**FINDINGS AND RECOMMENDATION
OFFICE OF PLANNING AND ZONING
ANNE ARUNDEL COUNTY, MARYLAND**

CASE NUMBER: 2024-0201-V

REQUEST

The applicants are requesting a variance to allow a dwelling addition (porch and deck) with less setbacks than required on property located at 1329 Washington Drive in Annapolis.

LOCATION DRAWING
LOT 52 BLOCK 4 PLAT 1
OYSTER HARBOR
SECOND DISTRICT
ANNE ARUNDEL COUNTY, MARYLAND
SCALE: 1" = 20' AUGUST 2018

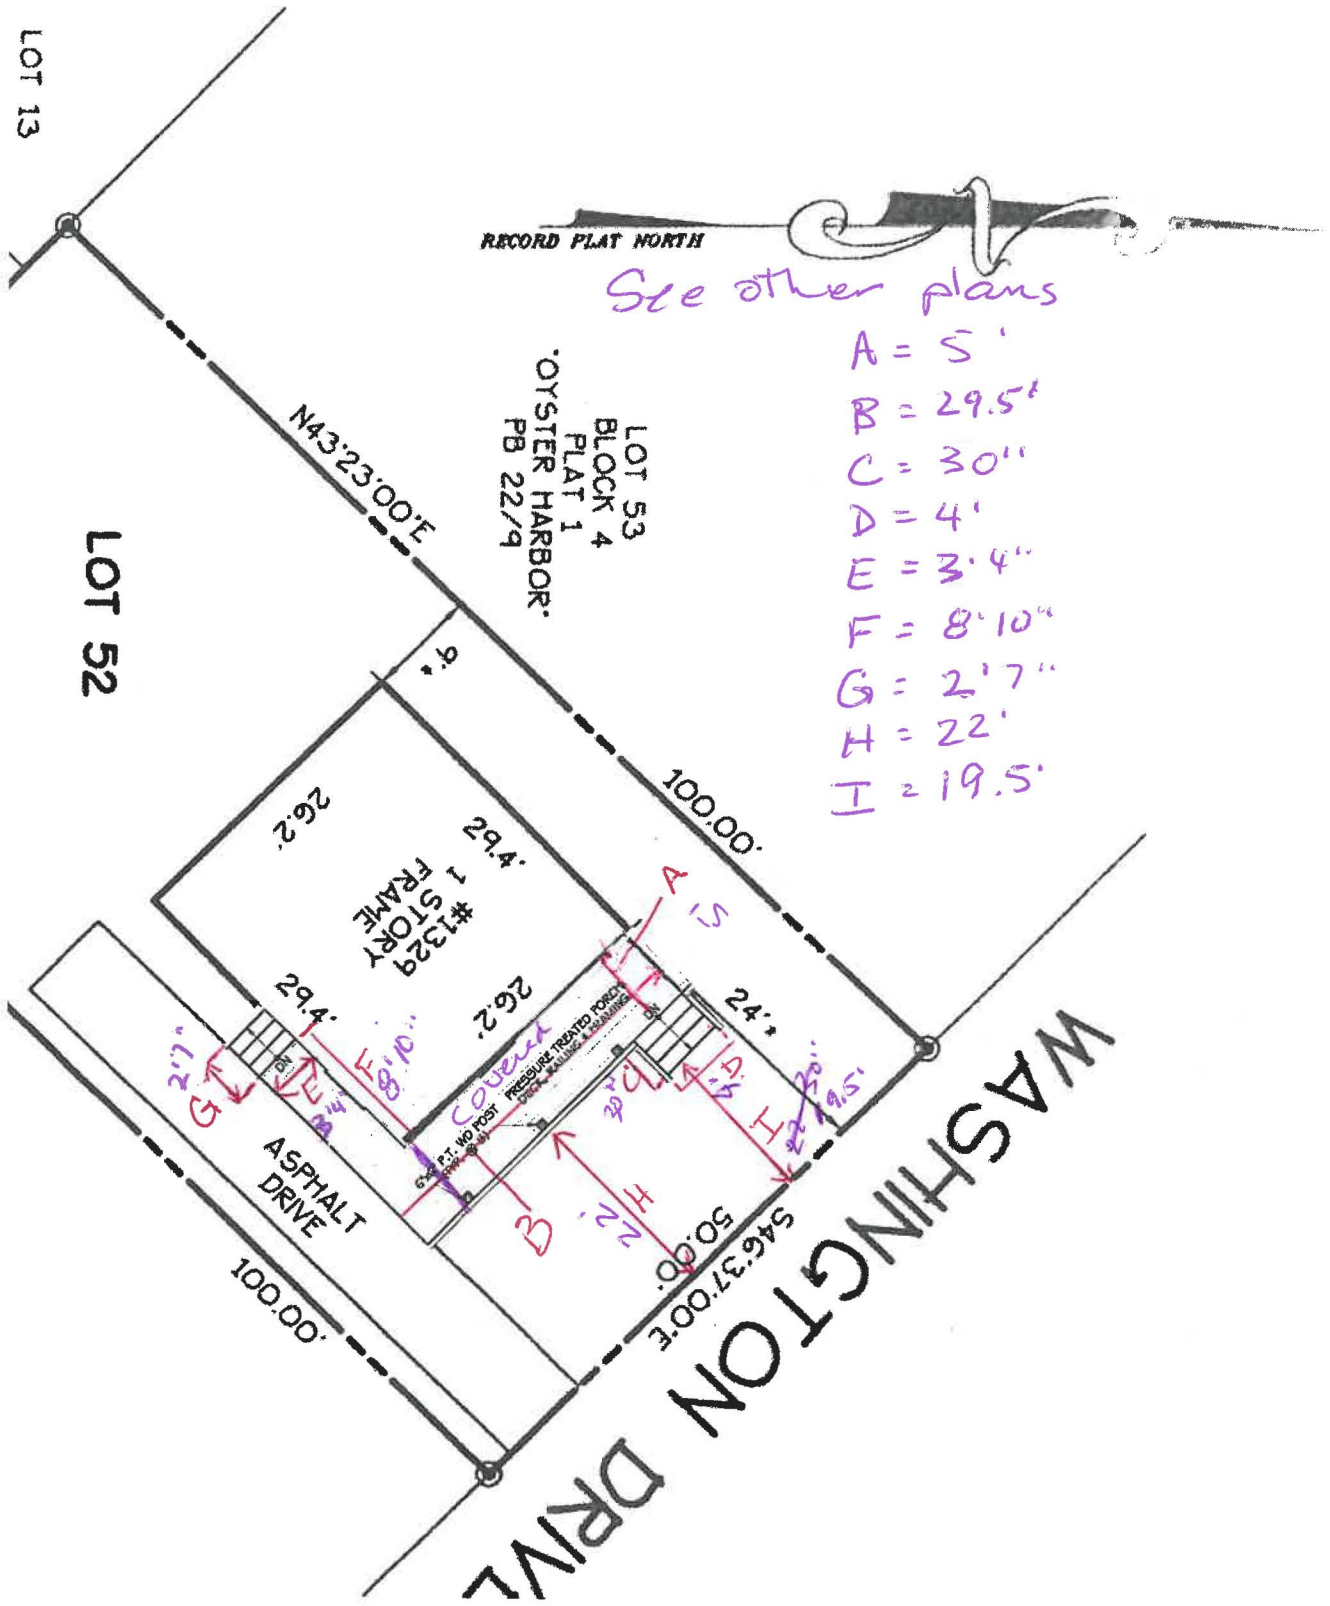
¹ The Administrative Site Plan erroneously notes that the proposed porch would be as close as 22 feet from the front lot line. However, the location survey showing the existing conditions indicates that the dwelling is 24 feet from the front lot line. Therefore, a 5 foot deep porch would be 19 feet from the front lot line, requiring a variance of 6 feet. A revised site plan was not received at the time of this report.
